N69172A-01

Modification Recommended Service Note

N69172A Advanced Power System

Figure 1: Incorrect label

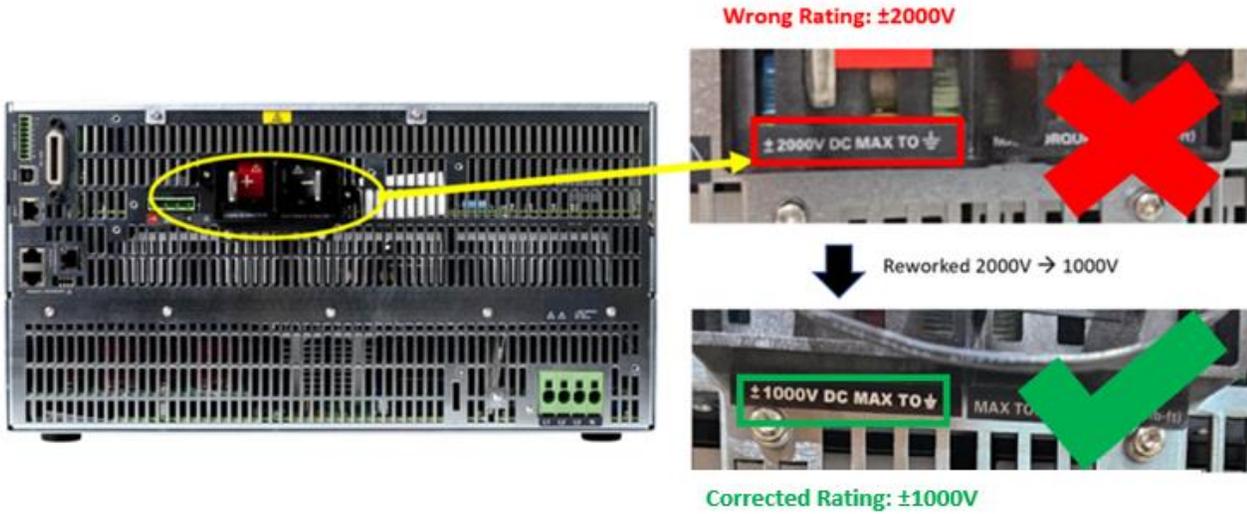
The Problem – Incorrect label of “Float Voltage Rating”.

For the Serial Number listed, the value of “Float Voltage Rating” has printed incorrectly on the label. The $\pm 2000V$ label is incorrect and should be replaced with $\pm 1000V$ label as shown in Figure 1.

When sending the instrument to the service centre for calibration or repair, label will be changed accordingly.
